STATE OF CONNECTICUT
CONNECTICUT SITING COUNCIL

RE: **PETITION NO. 983** - BNE Energy, Inc. Declaratory Ruling that no Certificate of Environmental Compatibility and Public Need is required for the construction, maintenance, and operation of a 4.8 MW Wind Renewable Generating facility located on Flagg Hill Road, Colebrook, Connecticut. **Development and Management Plan.**

Petition No. 983
Revised D&M Plan
Staff Report
February 7, 2013

Approved D&M Site Plan

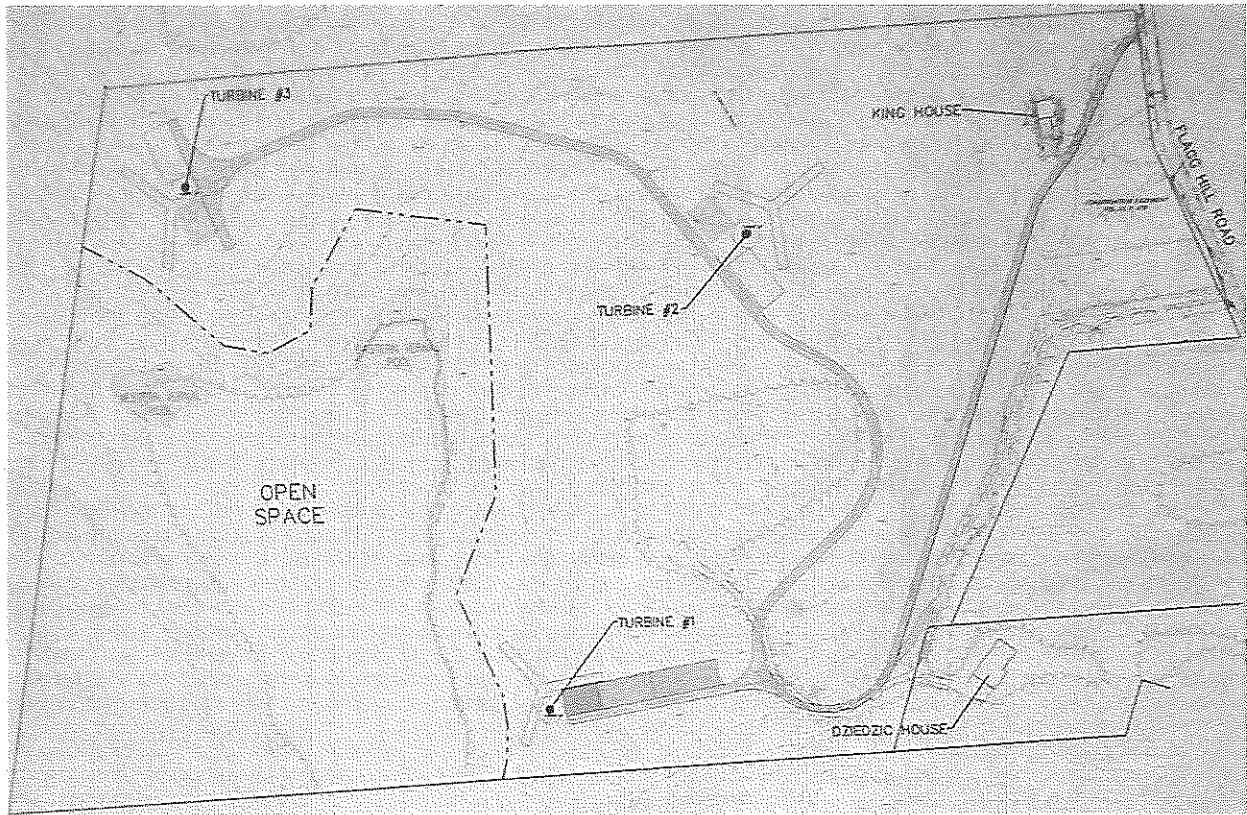
BNE submitted a revised Development and Management Plan (Revised D&M Plan) on November 2, 2012. BNE purchased the adjacent 5-acre parcel and existing residence known as 29A Flagg Hill Road to the southeast of the subject property owned by Hirtle and thereby seeks to modify the access road that was approved on November 17, 2011.

The Revised D&M Plan access road modification would utilize 1,200 feet of existing gravel driveway that serves the residence at 29A Flagg Hill Road in lieu of construction of 1,500 feet of new access road, as previously approved by the Council. By utilizing the existing driveway, construction impacts associated with the clearing, extensive grading, and ditching of a new road along a steep hillside would be avoided. The new access road alignment would not use the existing driveway to 17 Flagg Hill Road as previously approved, but instead would extend from the existing driveway serving 29A Flagg Hill Road at a more moderate grade to the previously approved road alignment.

The access road would be further modified to pass along the gravel driveway previously constructed for the wind testing tower, then through the western portion of the existing meadow near the center of the property rather than along the eastern boundary of the existing meadow. This new alignment through the western portion of the meadow would eliminate the construction of a hairpin turn and extensive grading along a steep slope west of the meadow.

The 350 foot by 60 foot crane pad, tower laydown area, crane assembly area, staging area and material processing area located at the southern turbine site (Turbine #1 site) would be reduced to a 200 foot by 60 foot crane pad and tower laydown area. The crane assembly area, staging area and material processing area would be re-located from the Turbine #1 site to the western portion of the existing meadow. Approximately 0.94 acres of the existing cleared meadow area would be disturbed by this relocated crane assembly area, staging area and material processing area during construction and it would serve both the Turbine #1 site and the northeastern turbine site (Turbine #2 site). However, 2.64 acres of existing cleared meadow would be left undisturbed during construction. BNE was unable to avoid the meadow area completely; otherwise, the access road location would result in additional clearing within the 750-foot vernal pool clearing envelope (to the west).

The Turbine #1 site would be re-located approximately 135 feet to the east onto more gentle sloping terrain of the knoll farther away from the wetland area/beaver pond on the site (265 feet). This would result in 6,100 square feet of less tree clearing within 100 feet of the beaver pond. While the southern turbine would be about 135 feet closer to the home on 29A Flagg Hill Road, this home is now owned by BNE. The setback distance of the southern turbine from the existing residence at 29A Flagg Hill Road would decrease from 1005 feet to 870 feet and the setback distance of the southern turbine from the property line at 29A Flagg Hill Road would decrease from 740 feet to 605 feet. This change in location would also cause the ground elevation to change from 1,449 feet above mean sea level (amsl) to 1,465 feet amsl. This is an increase of 16 feet.

The Turbine #2 site would be re-located approximately 167 feet to the southwest further into the interior of the host property onto more gentle sloping terrain, which would significantly reduce the amount of fill by 12,550 cubic yards. The northeastern turbine would be located roughly 100 feet farther south of The Northwest Connecticut Sportsman's Association property boundary to the north. This change in location would also cause the ground elevation to change from 1,457 feet amsl to 1,479 feet amsl. This is an increase of 22 feet.

At a public meeting of the Connecticut Siting Council (Council) held on February 7, 2013, the Council considered and approved the modification to the Development and Management (D&M) Plan submitted for this project on November 2, 2012, with the following conditions:

- BNE shall submit a copy of the site plans and Stormwater Management Plan with Stormwater Pollution Prevention Plan stamped by a Professional Engineer duly licensed in the State of Connecticut within 60 days of the date of this letter;
- BNE shall submit a revision to the Wetland and Wildlife Restoration Plan submitted under condition 2(h) of the Decision and Order dated June 2, 2011 that is consistent with the approved modifications to the D&M Plan within 60 days of the date of this letter to be reviewed and approved by Council staff; and
- BNE shall remove erosion and sedimentation controls prior to the spring migration of reptiles and amphibians as deemed appropriate by Dr. Michael Klemens.

Proposed D&M Site Plan

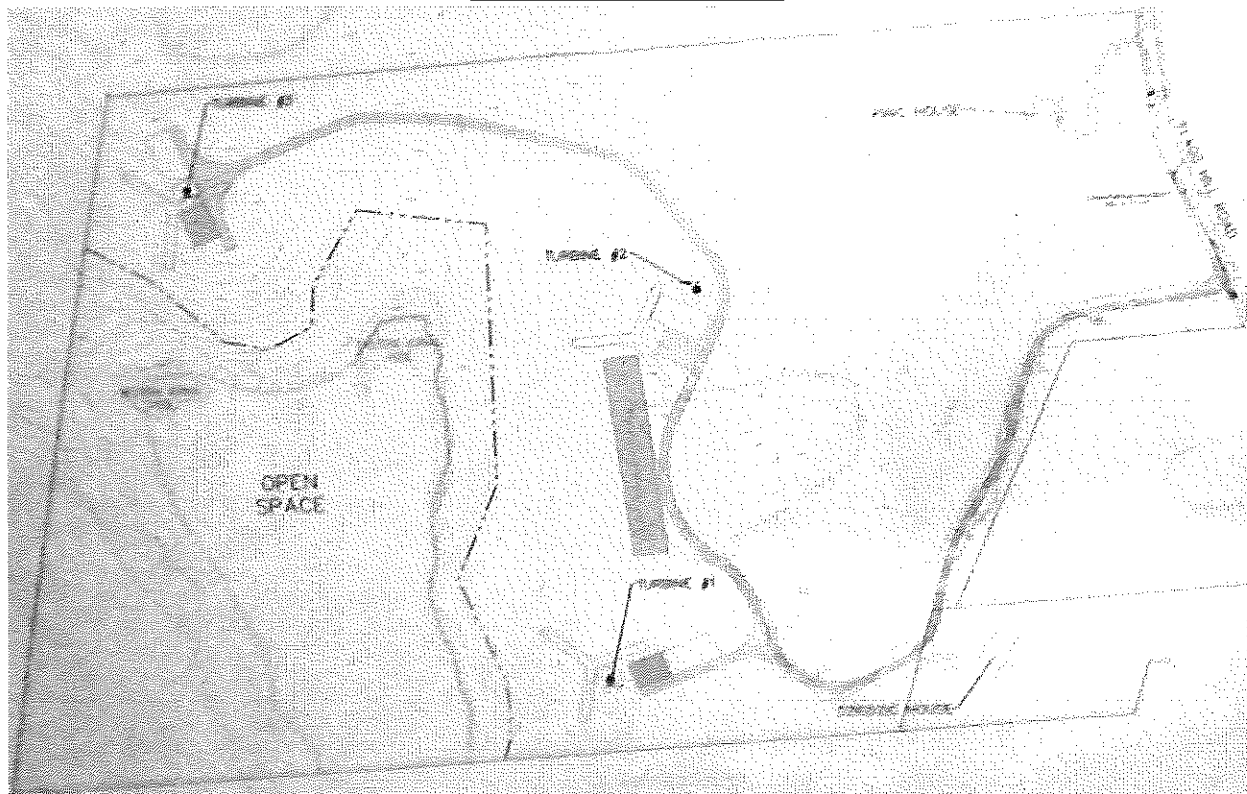
Approved Location of Turbine #1

Proposed Location of Turbine #1

Approved Location of Turbine #2

Proposed Location of Turbine #2
